RFP Title: Site Improvements at Gano Street Park

Addendum #: 1

SITE IMPROVEMENTS AT GANO STREET PARK

November 13, 2024

L-9

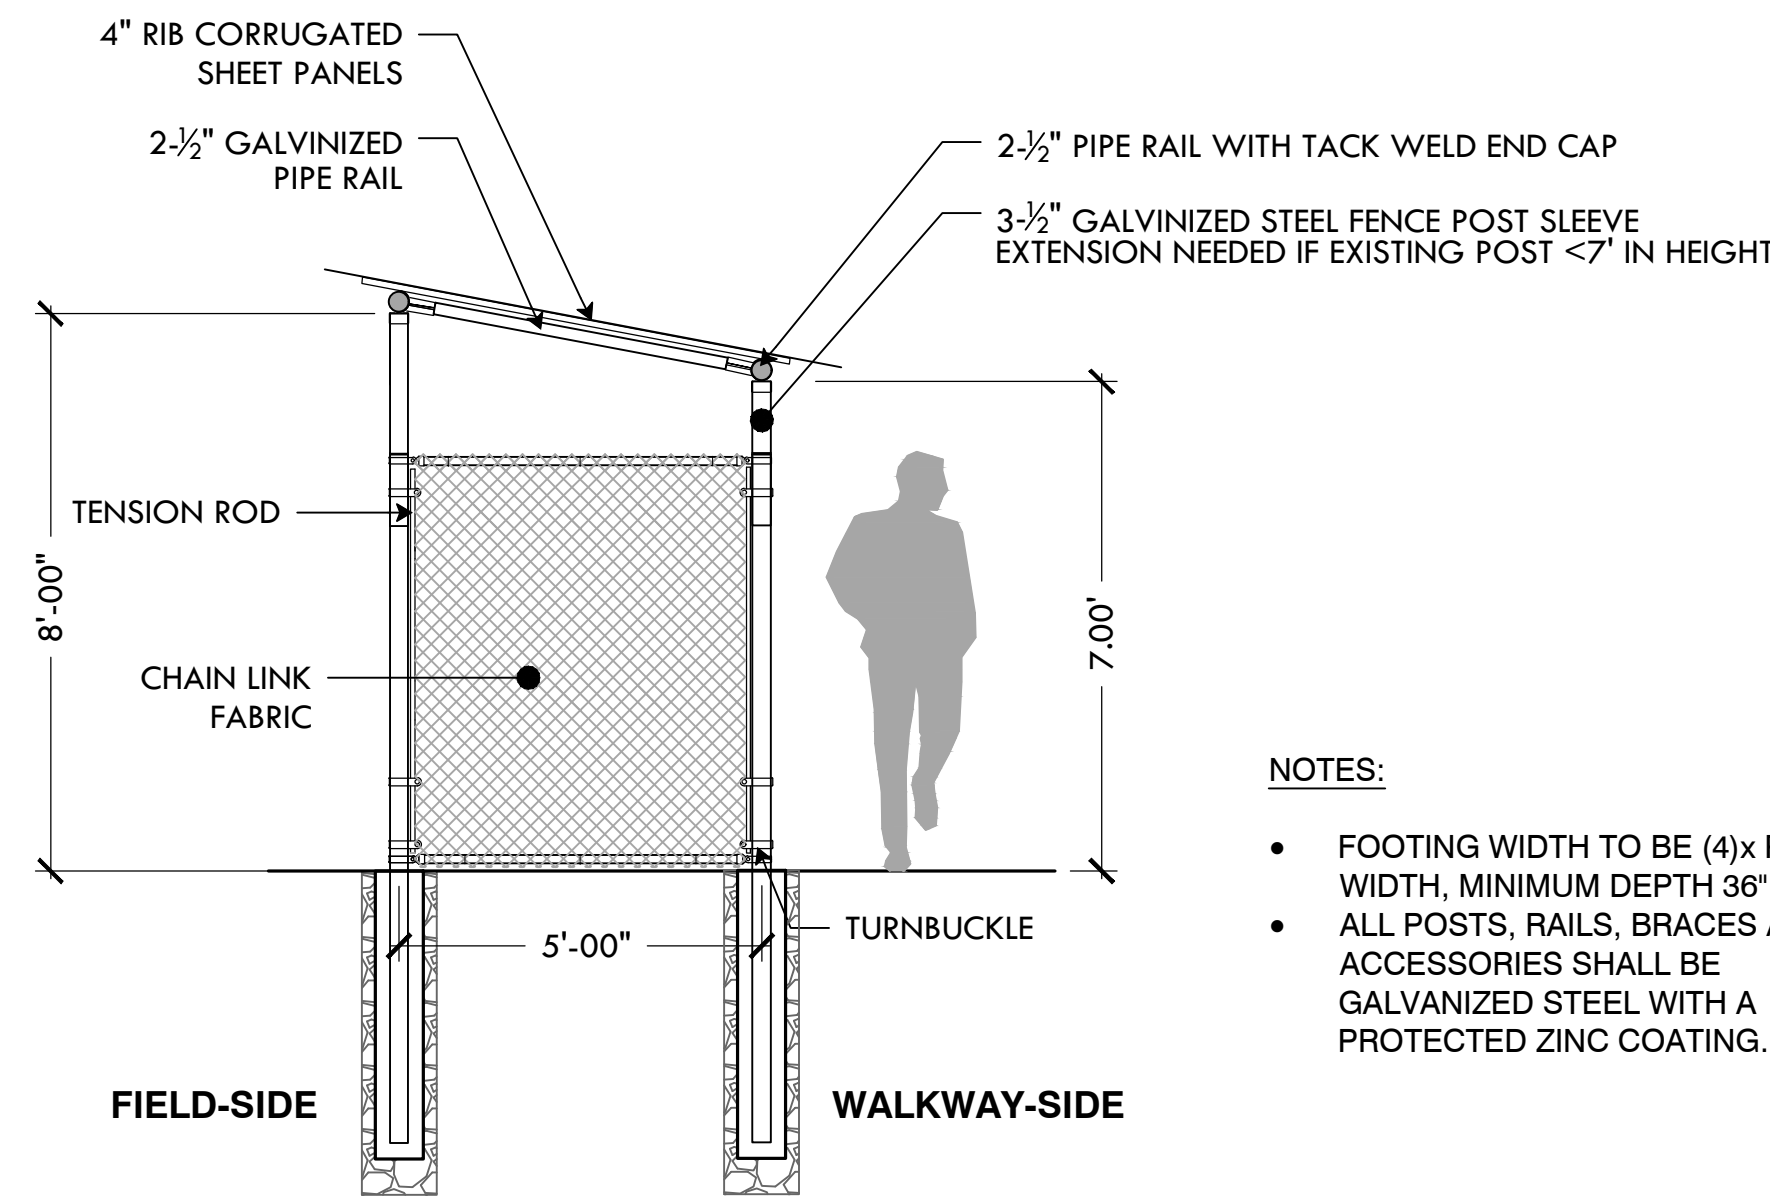
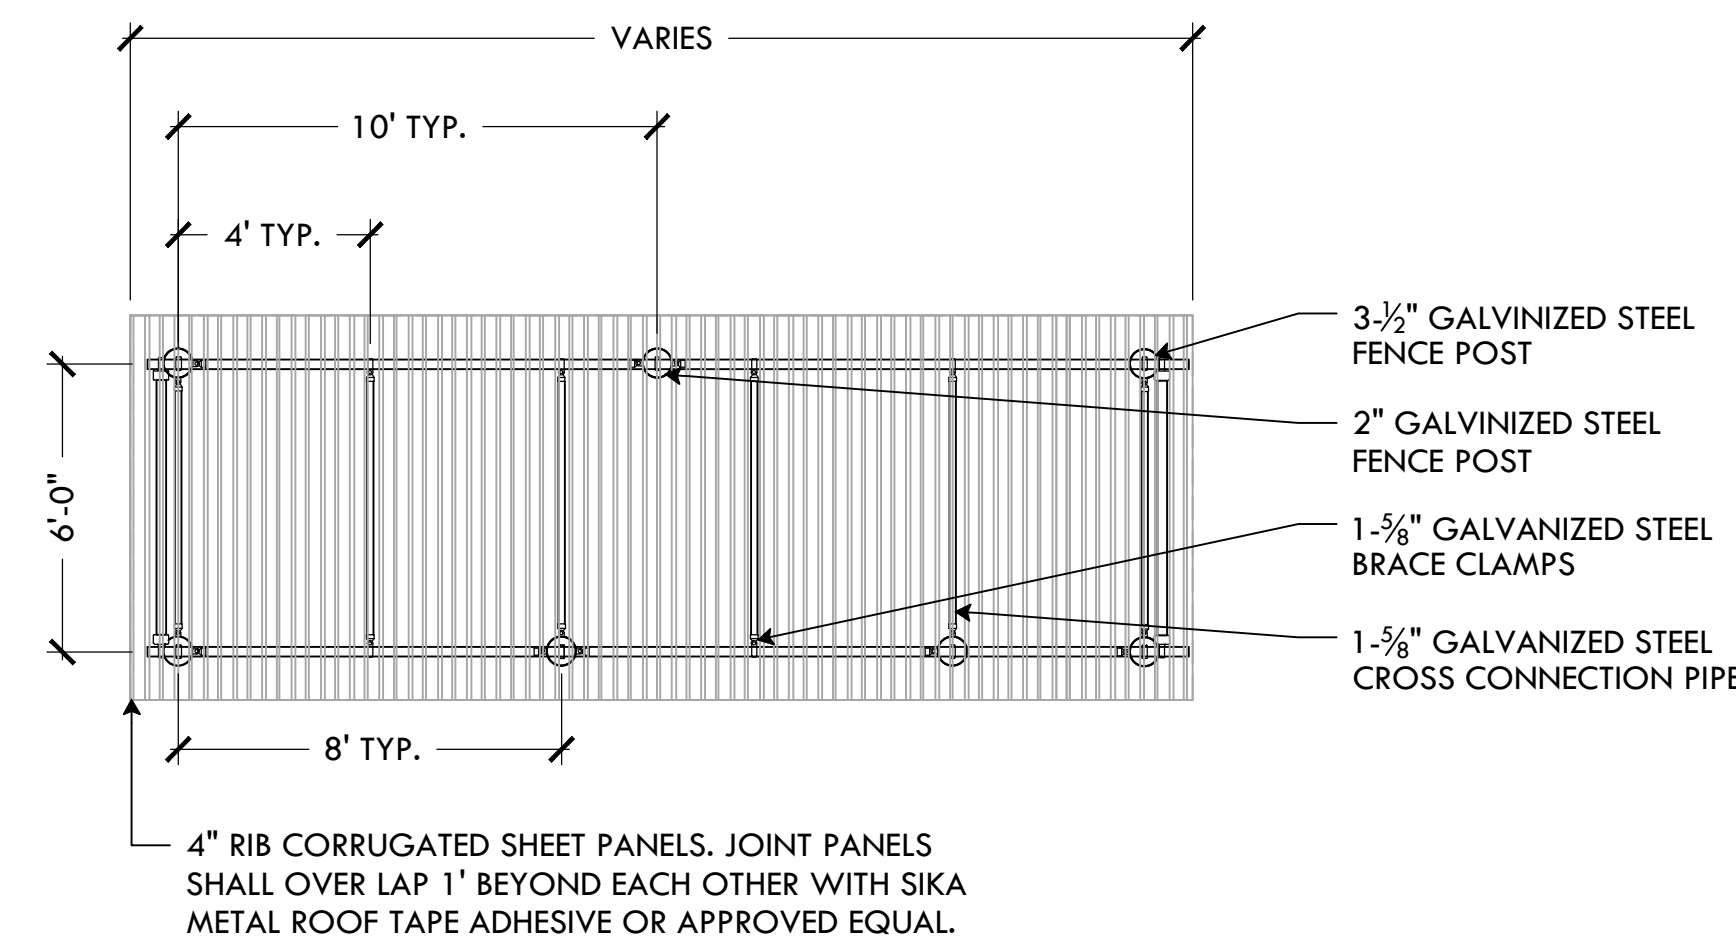
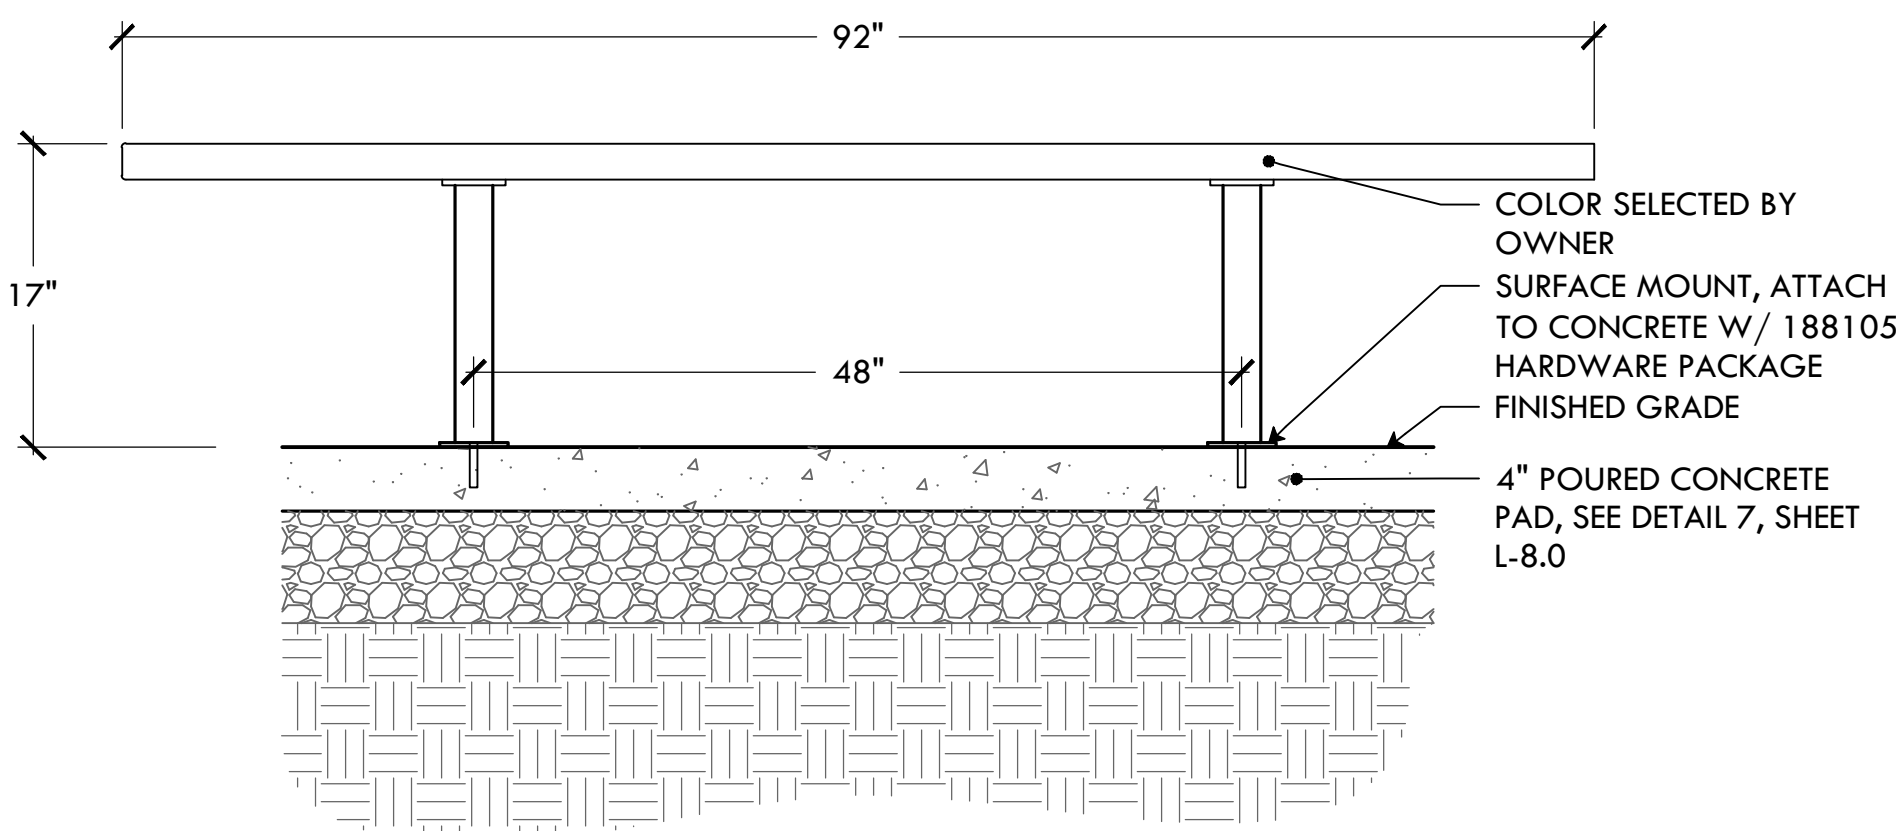
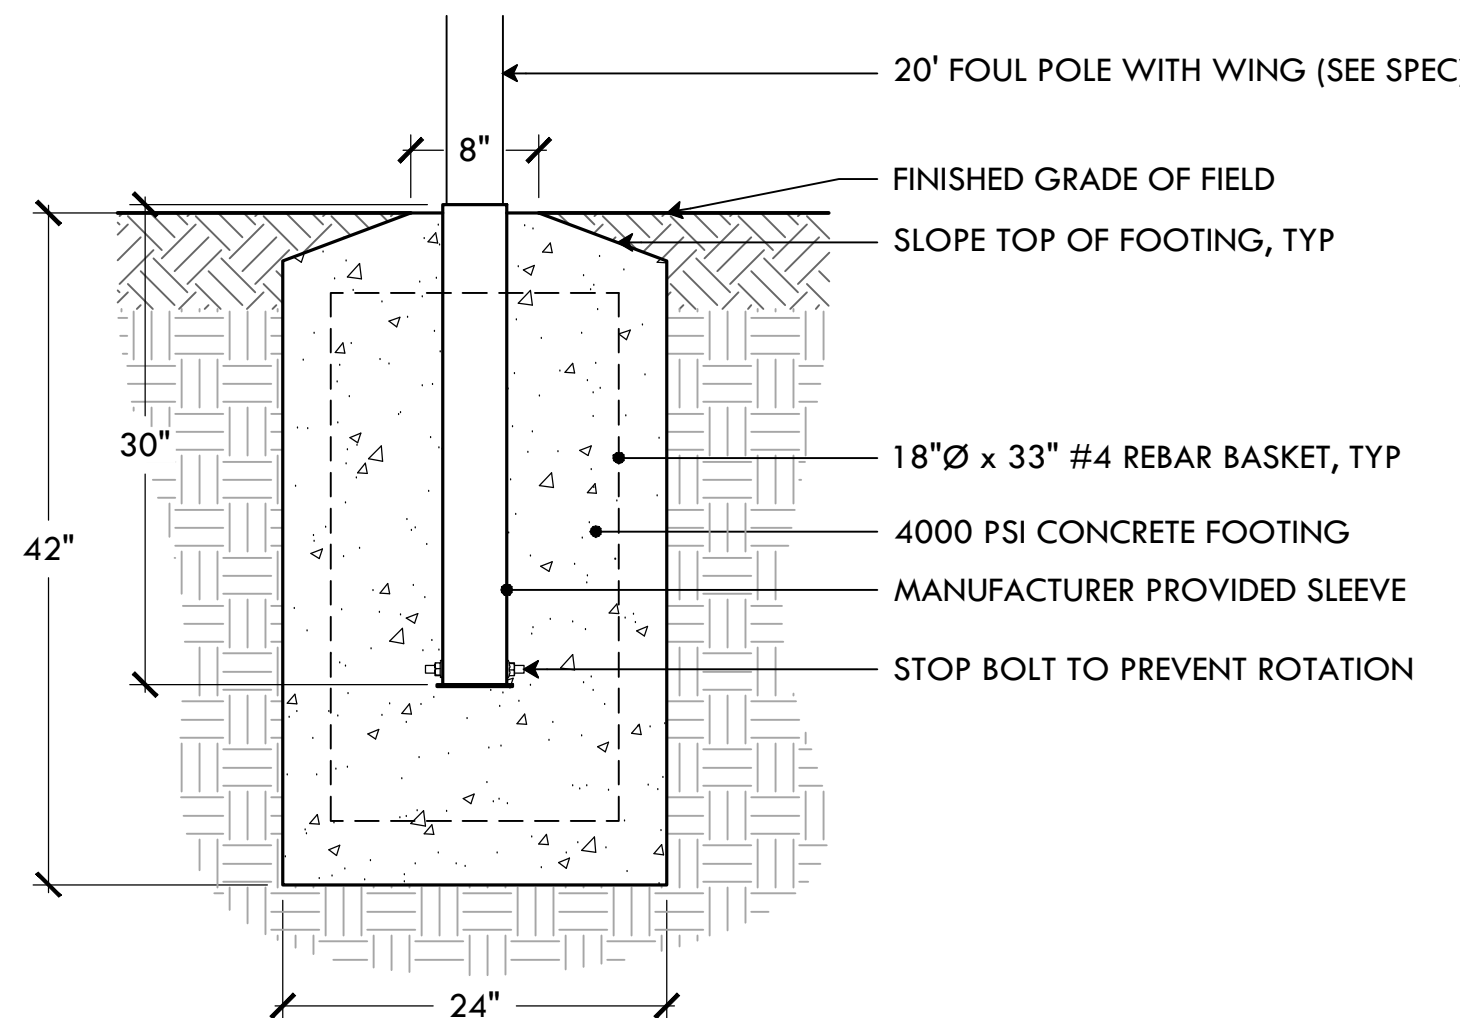
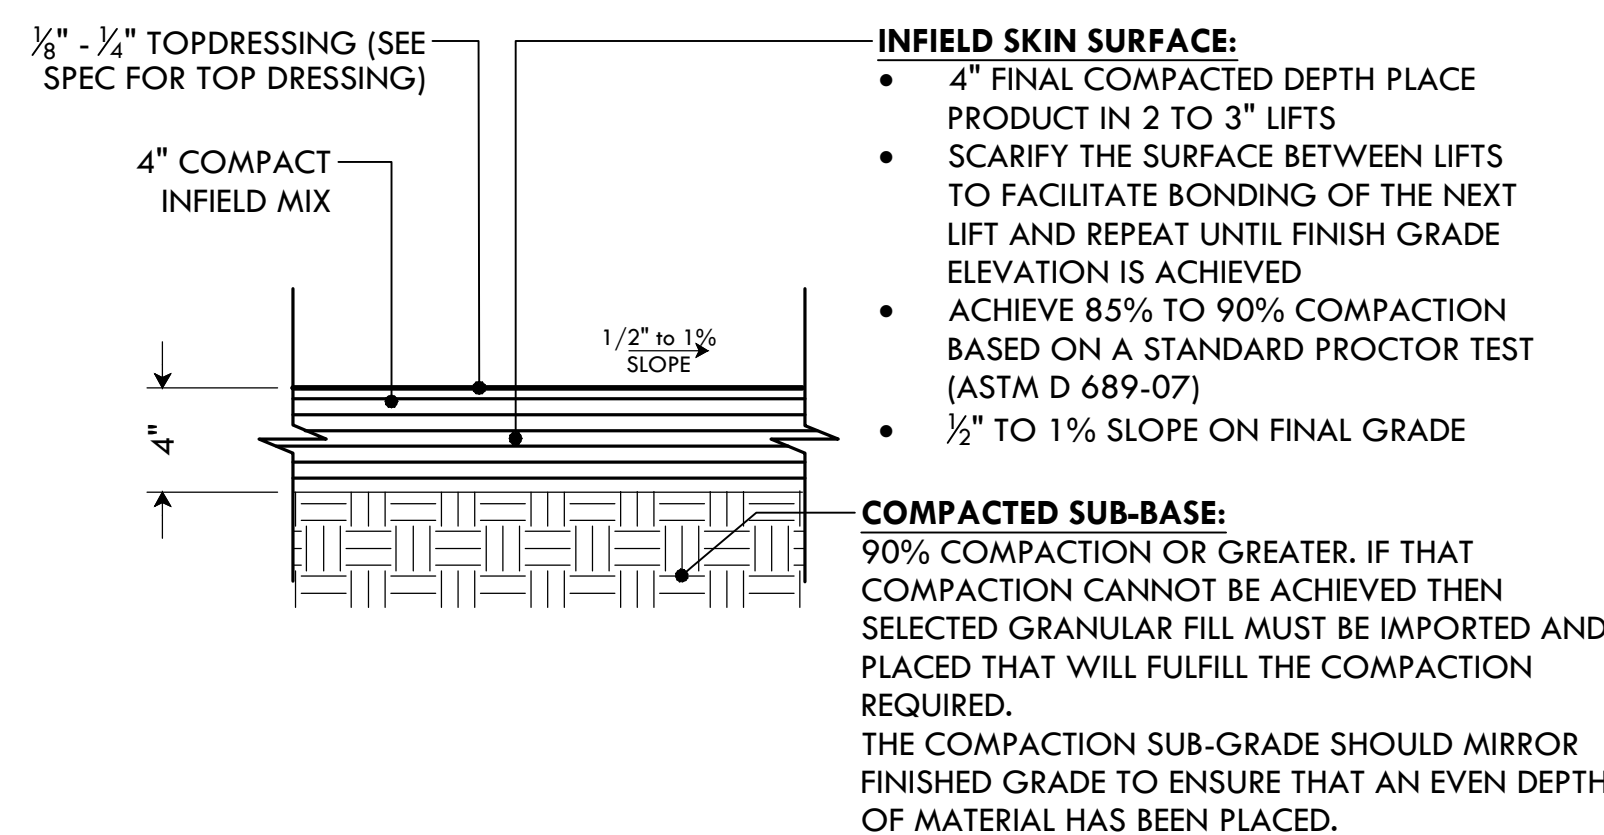
1. RFP p. 41, item #38 has been amended.
2. RFP p. 45, Drawings sheet schedule has been updated to reflect total number of sheets of lighting plans.
3. Technical Specifications for Site Furnishings have been updated to include dugout player's bench specifications.
4. Revisions made on plan set including sheets L-1, L-6, L-9, L-10, and L-11.
